Service Bulletin

Bulletin No.: 24-NA-247
Date: March, 2025

Subject: Information on Lower-Case Extension and Oil Pan Comparison

6756272

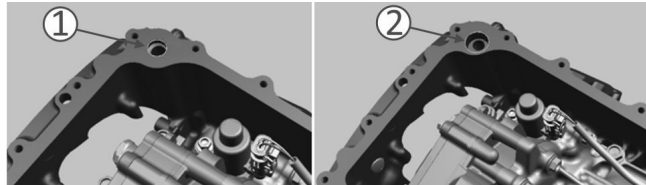
Locate the Part Unit Number (PUN) code on the side of the LCE for part validation.

If replacing the oil pan, verify the LCE oil flow check valve hole diameter.

- If hole diameter is 15.0mm (1) (LCE PN 12724347), repair with plastic oil pan (PN 12726914).
- If the hole diameter is 22.7mm (2) (LCE PN 12725073), install a check valve (PN 55501215) and aluminum oil pan (PN 12732388).

If the LCE is being replaced, service with PN 12725073, check valve, and aluminum oil pan.
